Infrastructure Renewal Phase 1A Project No. FM090074L/986080 **Addendum No. Six**

ADDENDUM NUMBER SIX

Construction Documents May 18, 2010

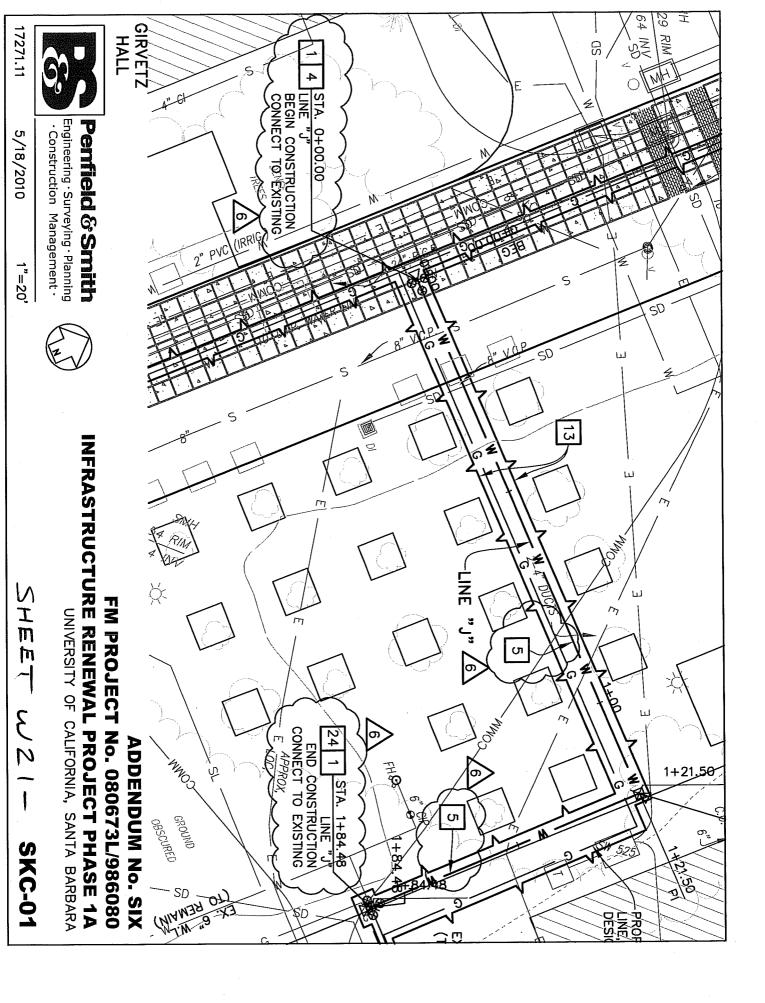
4. <u>W21, LINE 'H', 'I', 'J' WATERLINE PLAN & PROFILE INFRASTRUCTURE</u> RENEWAL PROJECT, **ADD** the following note in it's entirety:,

"STA. 0+00.00 LINE "J" BEGIN CONSTRUCTION CONNECT TO EXISTING AND STA. 1+84.48 LINE "J" END CONSTRUCTION CONNECT TO EXISTING." Sketch attached.
